Changing the Shape of the Attachment (GT15-70ATT-98) for GOT2000 Series and GOT1000 Series

This bulletin informs you that the shape of the panel installation part of the attachment (GT15-70ATT-98) for GOT2000 series and GOT1000 series will be changed.

GOT-A-0189-A

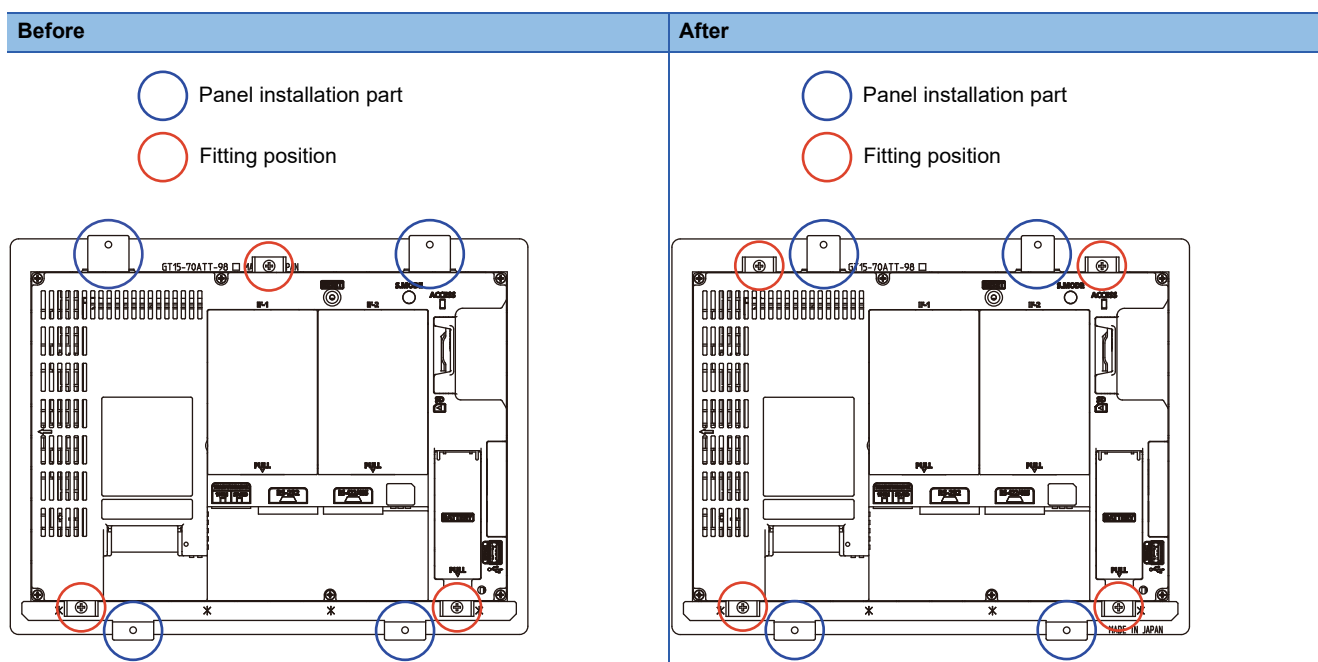
The fitting positions and shape of the panel installation part on the top of the attachment will be changed.
 With this change, you can install the GOT2000 series using four fittings at four fixing positions.
 With three fittings, the GOT has satisfied the vibration resistance specification for GOTs before the change.
 Even before or after the change, you can use the GOT1000 series with the four fittings at four fixing positions.
